**Final  
Technical Memorandum No.2  
Addendum to Final Phase I RFI/RI  
Work Plan Surface Geophysical Surveys  
Operable Unit No.5**

APPENDIX 2 - AGENCY COMMENTS WITH REPLY TO DRAFT TECHNICAL  
MEMORANDUM No. 2 (JULY 31, 1992)

### REPLY AND DISPOSITION OF AGENCY COMMENTS TO DRAFT TECHNICAL MEMORANDUM No. 2 (July 31, 1992)

3. Document No./Title: Draft Technical Memorandum No. 2, Addendum to Final Phase I RFI/RI Work Plan Surface Geophysical Surveys, Rocky Flats Plant, Woman Creek Priority Drainage Revision 0, July 31, 1992

FIGURE 2.7

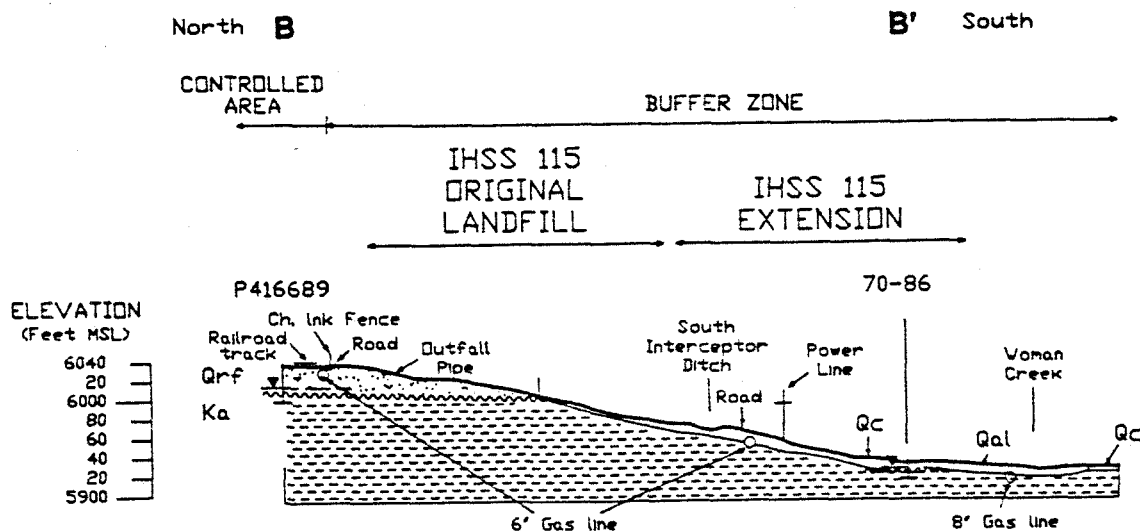
Item	Comment(s)	Disposition
Figure 2.7	The oblique aerial photo included as Figure 2.7 should have a date indicated on the photo label.	The photograph used in Figure 2.7 is provided with the date of June 6.
General	An HPGe radiation survey is planned for the ash pits area covering the same area that will be geophysically surveyed. We recommend that the HPGe survey precede the geophysical surveys.	This general comment restates the task work prioritization for Stage 2 screening specified in the OU5 RFI/RI Work Plan, Phase I Field Sampling Plan, dated February 1992. A statement so indicating this directive for the Ash Pits has been added to Section 2.1.3 indicating this part of the site assessment task sequence.

**IHSS 115**  
**GEOLOGIC CROSS SECTIONS**  
**A - A' AND B - B'**  
**WOMAN CREEK PRIORITY**  
**DRAINAGE AREA**  
**(OPERABLE UNIT 5)**  
**TECHNICAL MEMORANDUM 2**

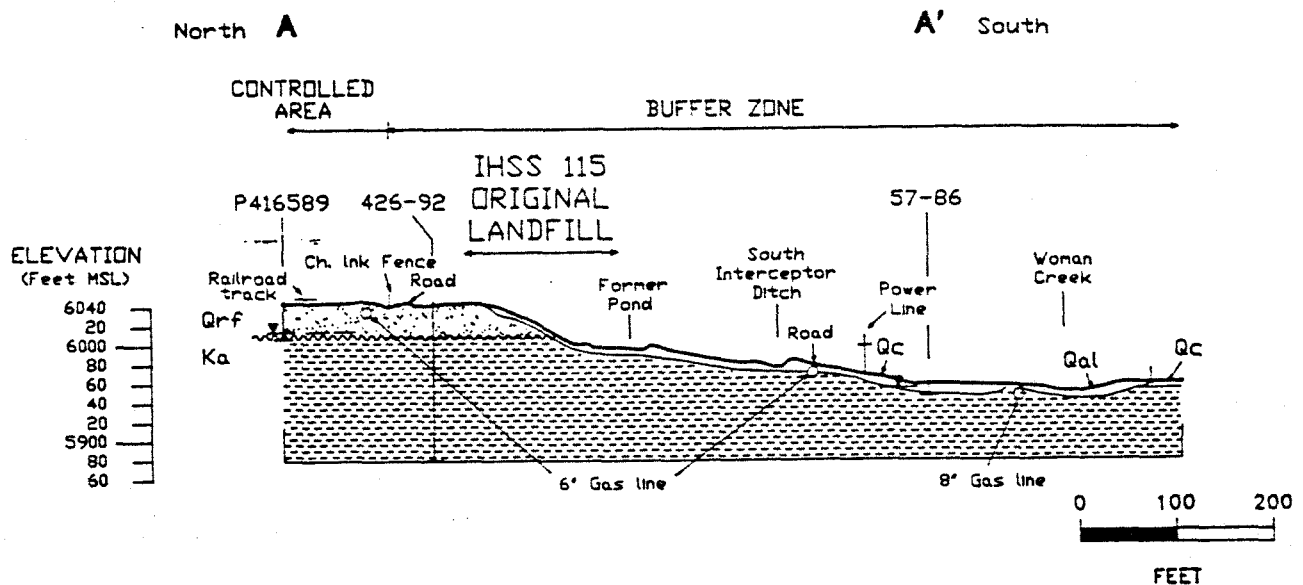
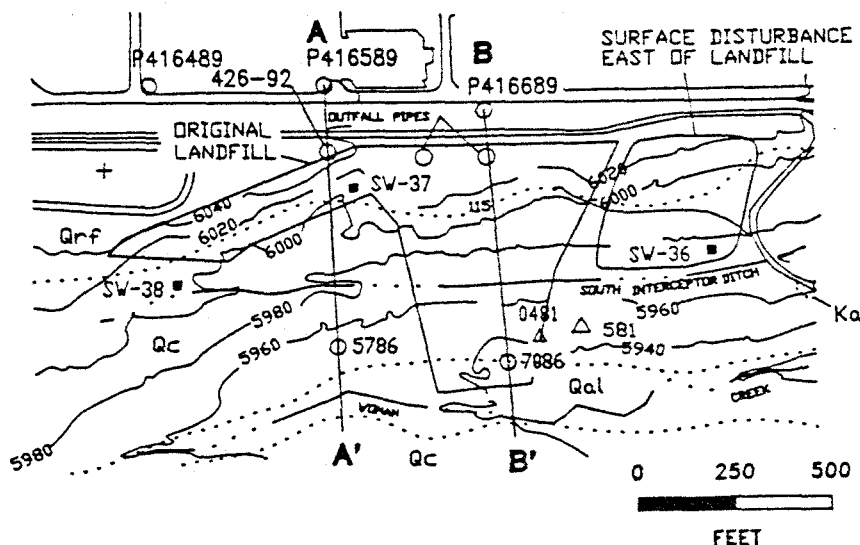
Item	Comment(s)	Disposition
Section 2.1.1, Page 7, Second Paragraph.	Because the area of the landfill was not geologically mapped before dumping began, and has not been drilled through, any cross sections are speculative. Therefore, the presence of permeable alluvium or colluvium, or the lithology of the Arapahoe formation underlying the landfill is currently speculative also. Analysis of the dip angle and trends of the Arapahoe number 3, 4, and 5 sandstones indicate the possibility that one or more of these relatively permeable lithologies subcrop (underlie) the landfill. If this is the case, leachate flow could take a different direction than stated. This section should recognize this possibility.	Bore hole 426-92 was drilled north and adjacent to the Original Landfill in 1992. It was drilled to a depth of 158 feet, and is added to cross section A-A' in TM2. This hole confirms the lithology and stratigraphy originally shown on the cross section, and confirms that the landfill is underlain by claystones of the Arapahoe Formation. Because of lost core intervals, it could not be fully determined from the lithologic logs if some Arapahoe Sandstone intervals could exist in the bore hole. Annetta Primerose of EG&G/RFP confirmed (October 1, 1992) that the electric logs of hole 426-92 indicated that the entire interval below the unconformity/bedrock contact consists entirely of claystone. The information provided in the cross sections is valid.

**EG&G** **FIGURE 1.4**  
Rocky Flats Plant, Golden, Colorado

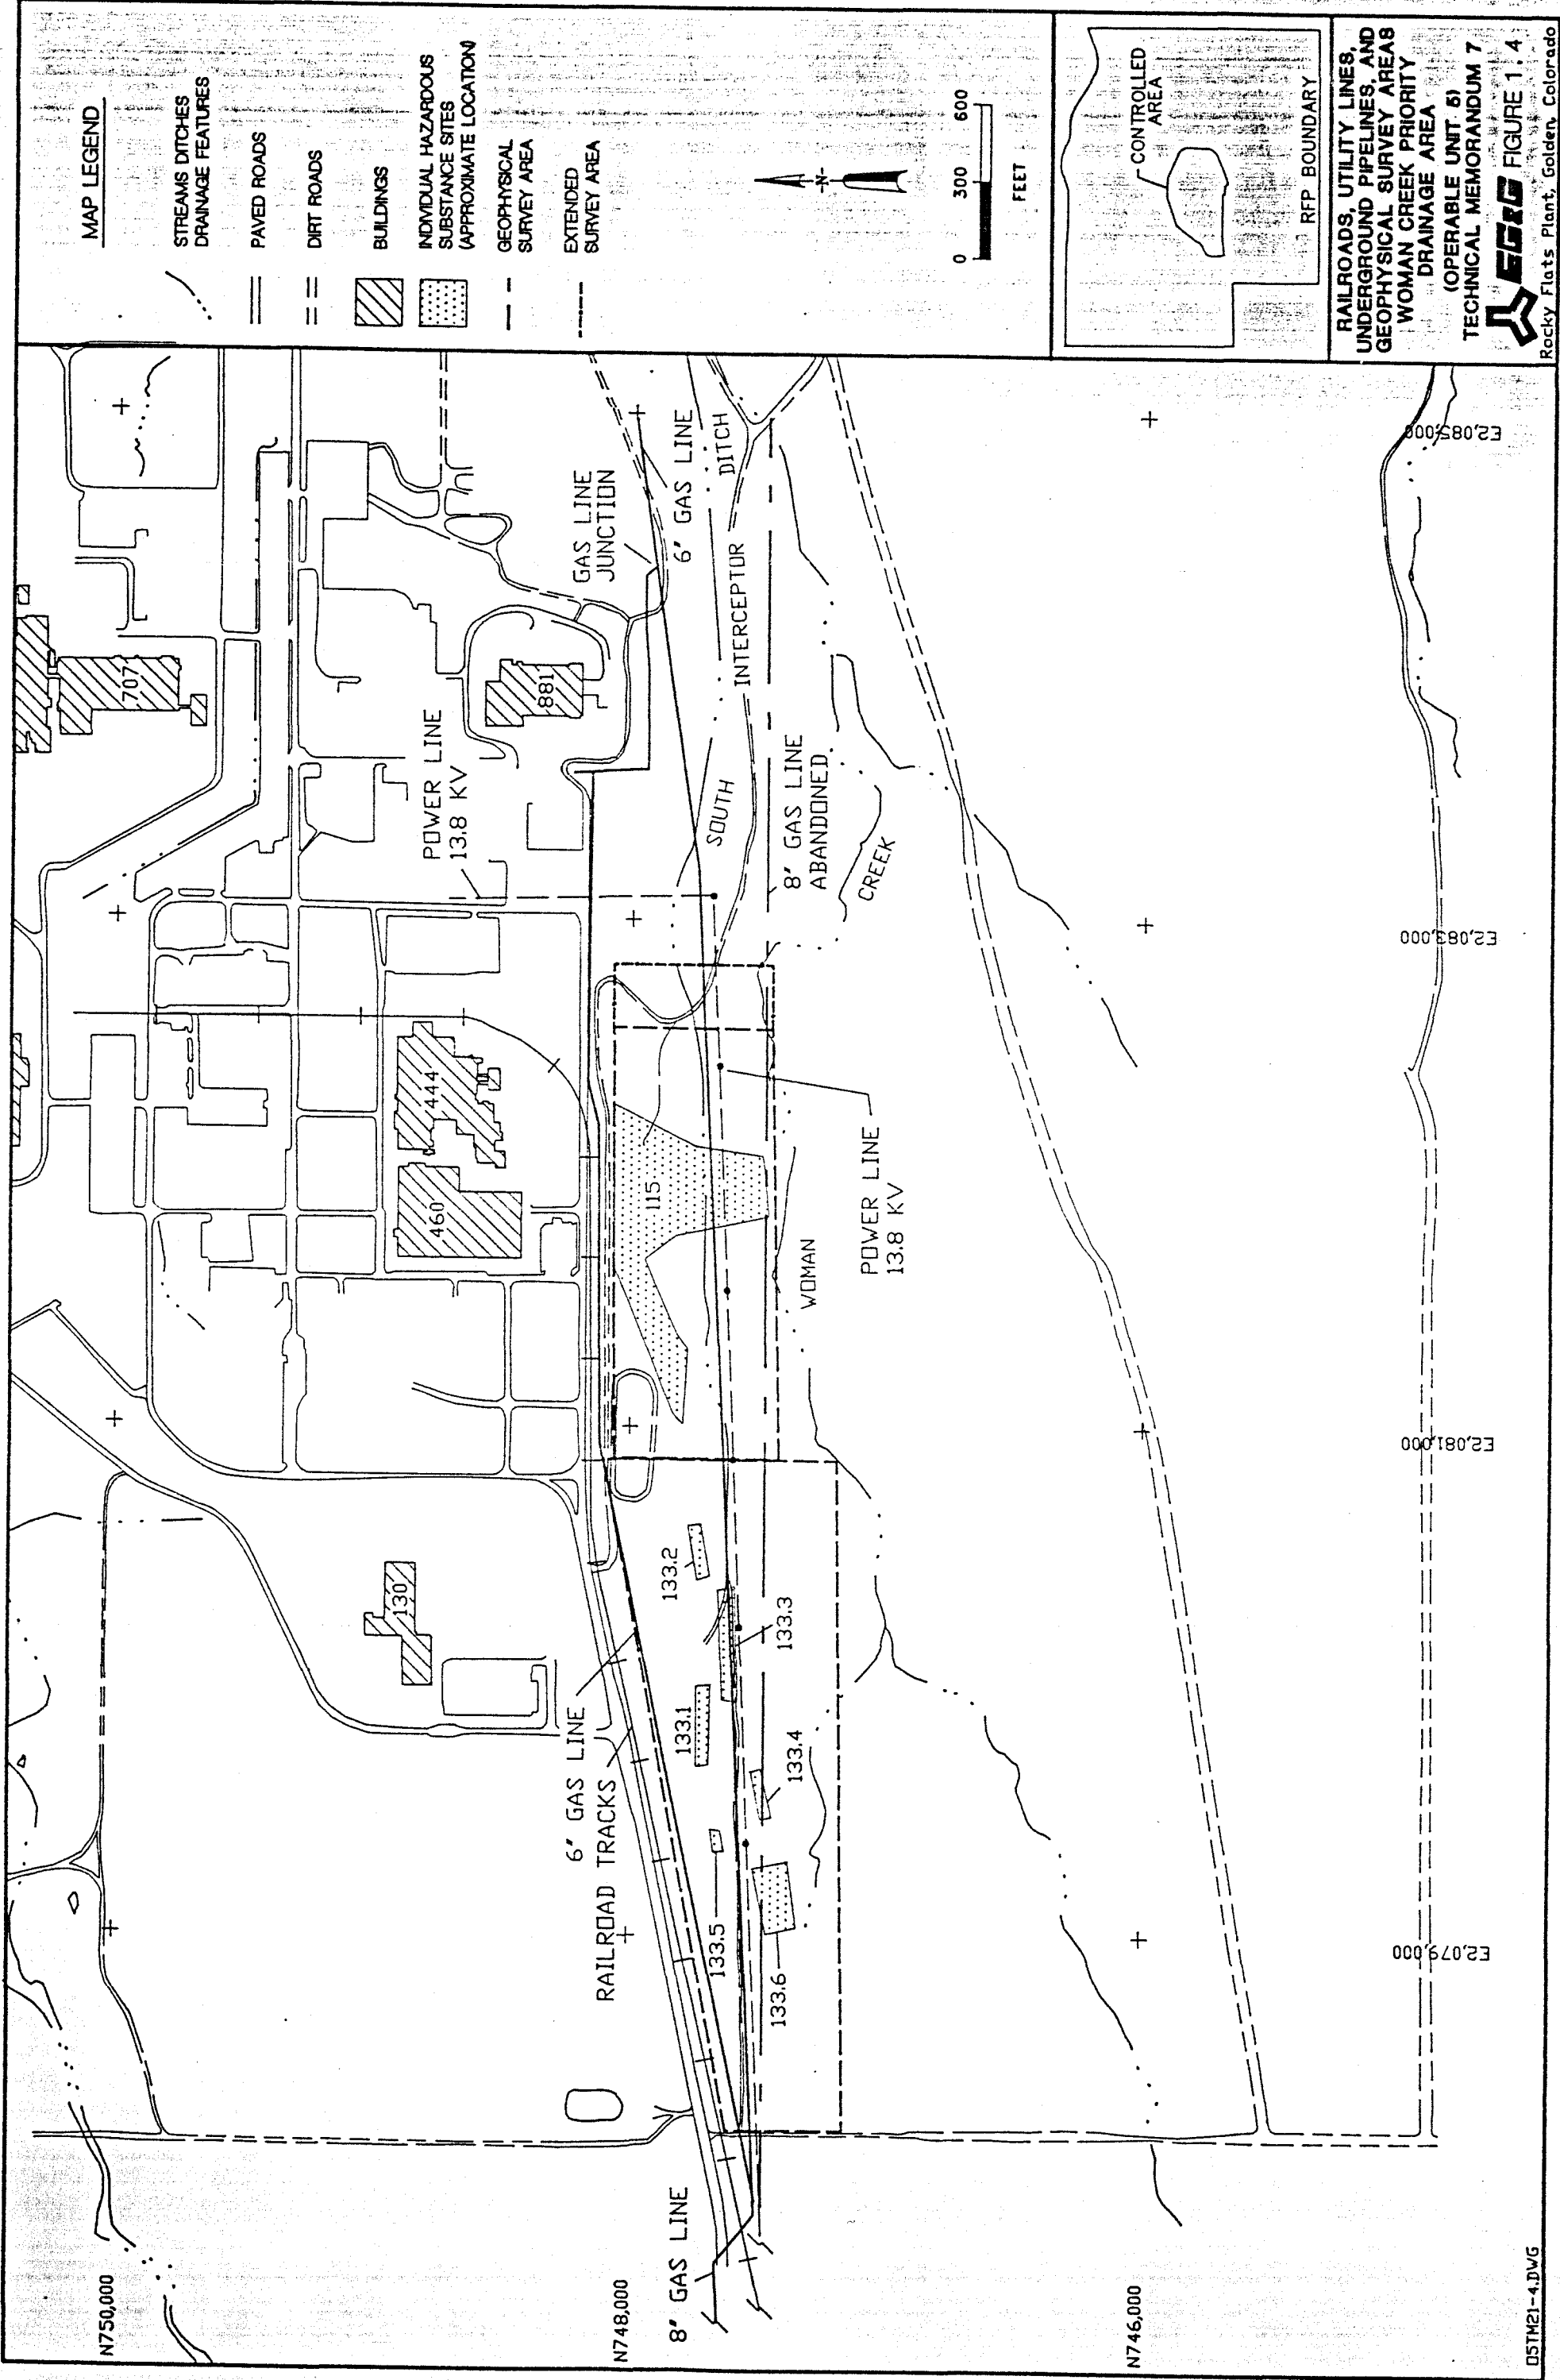
Item	Comment(s)	Disposition
Figure 1.4	<p>The trapezoidal geophysical survey area for the ash pits shown on Figure 1.4 does not include several of the anomalies indicated on Figure 2.8. In addition, it differs from the survey area presented in the Final OU 5 RFI/RI Work Plan. We recommend expanding the survey area westward approximately 200' to pick up the disturbed ground area west of the access road and expanding it as far northward as possible to pick up the new possible ash pits. Also, to be consistent with the text of TM 2 and the Work Plan for OU 5, the area shown on Figure 1.4 should be expanded southward to Woman Creek.</p>	<p>Figure 1.4 of TM2 shows the original IHSS locations as delineated in the OU5 Phase I RFI/RI Work Plan, while Figure 2.8 shows the revised locations of the IHSS's and other features as identified during the initial review of the vertical aerial photographs. After the TM was submitted for review a set of oblique aerial photographs became available that made it possible to more accurately relocate the IHSS's in the 133 area and to further define other possible suspect features. The oblique photographs were subsequently used to confirm these features on the ground. As a result Figure 2.8 is updated with respect to the IHSS and suspect area locations.</p> <p>The areas of disturbed ground shown on the west side of the area were determined to be associated with road construction. These were discussed on pages 9 and 10 of TM2, and do not warrant further investigation.</p> <p>The north boundary of the survey area is adequately located to included all suspect areas that warrant further investigation. A ground survey of the area determined that some of the suspect areas are predominately dumped concrete with no indications of buried pits.</p> <p>The southern boundary of the geophysical surveys will be extended to conform to the boundaries of the radiation survey.</p>
